#### **REMARKS**

Claims 1-46, 50-56, 59 and 60 are currently pending in the present application. The Specification has been amended solely to correct clerical errors or improve readability, and corrected Figures 1, 2, 6, 7A, 9, 12-16 and 18 are included with the Request for Drawing Change submitted with this response.

FIG. 9

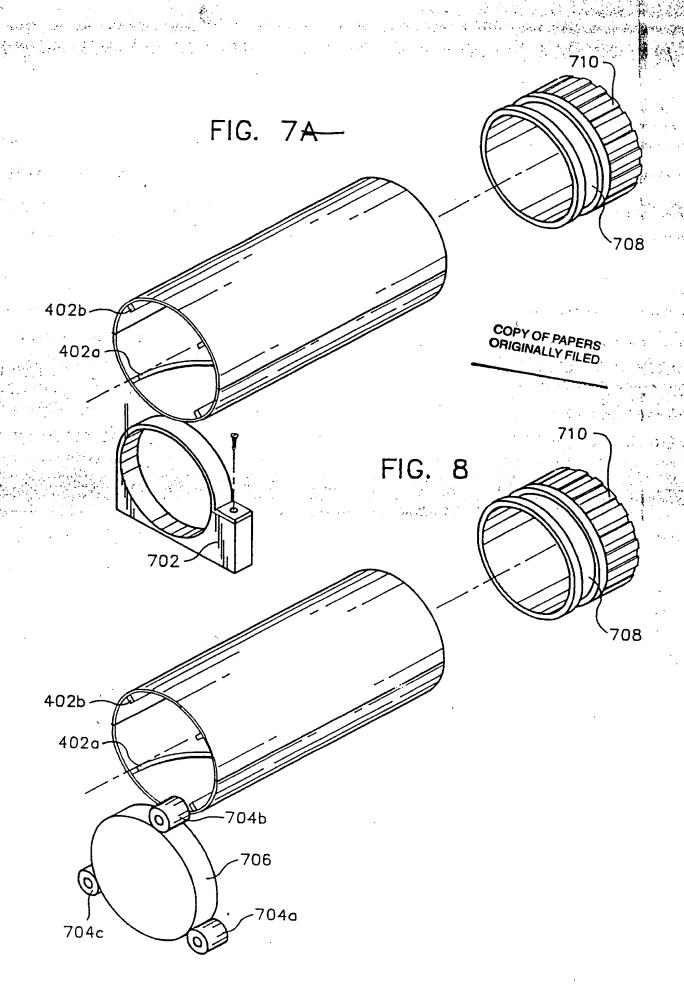
Figure 9 was objected to for including reference number 812 which allegedly is not mentioned in the description. A corrected Figure 9 without reference number 812 has been provided in the Request for Drawing Change submitted in response to this Office Action.
